SAFETY BULLETIN

Communication #: I-19-05-B

SUBJECT: 10A CIRCUIT BREAKER REPLACEMENT - FTR 1200 PURPOSE

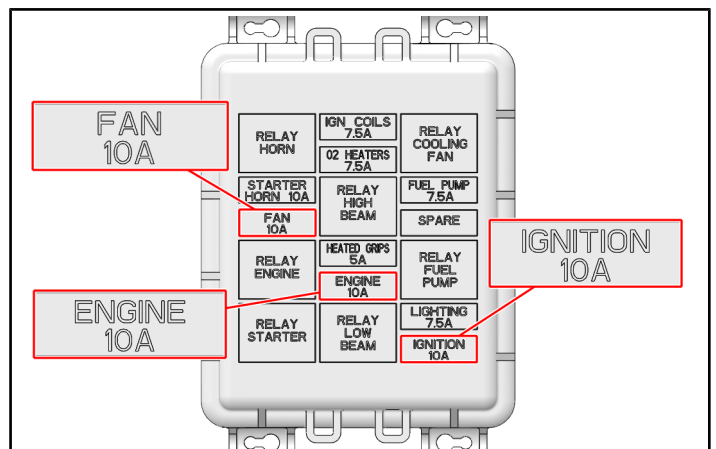
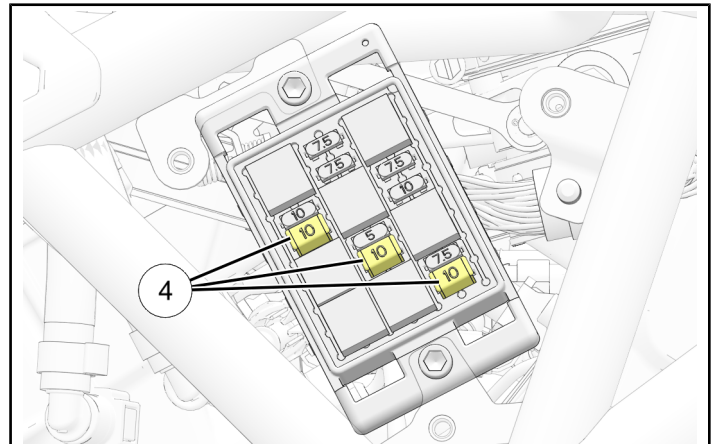
7. Identify the three 10A breakers ④ (marked FAN 10A, ENGINE 10A, and IGNITION 10A on the fusebox cover legend).

8. Remove three 10A breakers and discard.

9. Verify replacement breaker has red paint dot on it.

10. Install three replacement 10A breakers.
